Product / Process Change Notification (PCN)		
☒ Major Change ☐ Minor Change		
PCN Number: PCN_IndLQS_20241120 Affected Series: WE-LQS Affected Order Codes: Please see table below in "Details" PCN Date: 2024-08-20 (YYYY-MM-DD) Effective Date: 2024-11-20 (YYYY-MM-DD)	Change Category: ☐ Equipment/Location ☒ General Data ☐ Material ☐ Process ☐ Product Design ☐ Shipping/Packaging ☐ Supplier ☐ Software	
Contact: Product Management Phone: +49 (0) 7942 - 945 5001 Fax: +49 (0) 7942 - 945 5179 E-Mail: pcn.eisos@we-online.com	Datasheet Change: ☒ Yes ☐ No Attachment: ☐ Yes ☒ No	
Description of Change: To meet current customer demands, Würth Elektronik eiSos will add a dot on the article surface to show the start of winding (SOW). There will be no change in form, fit, function, quality or reliability of the product. The new revision of the affected order codes will be sent out after the previous revision is out of stock (according to FIFO - first-in, first-out).

Marking Change:

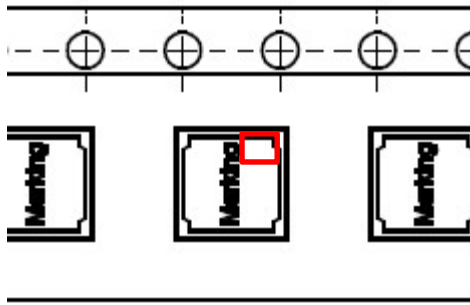
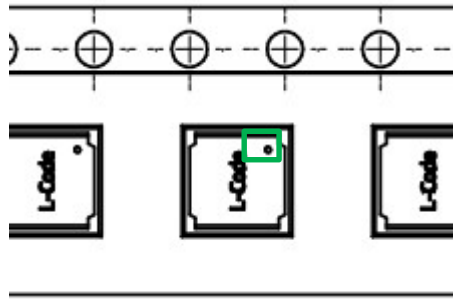
A dot for the start of winding will be added on the article surface to have the opportunity to place the part on the PCB in the best and a reliable way.

Order codes 74404041xxxx and 74404042xxxx

Before Change	After Change
Picture: Article Surface		
Picture: Schematic		
Picture: Article Orientation in reel
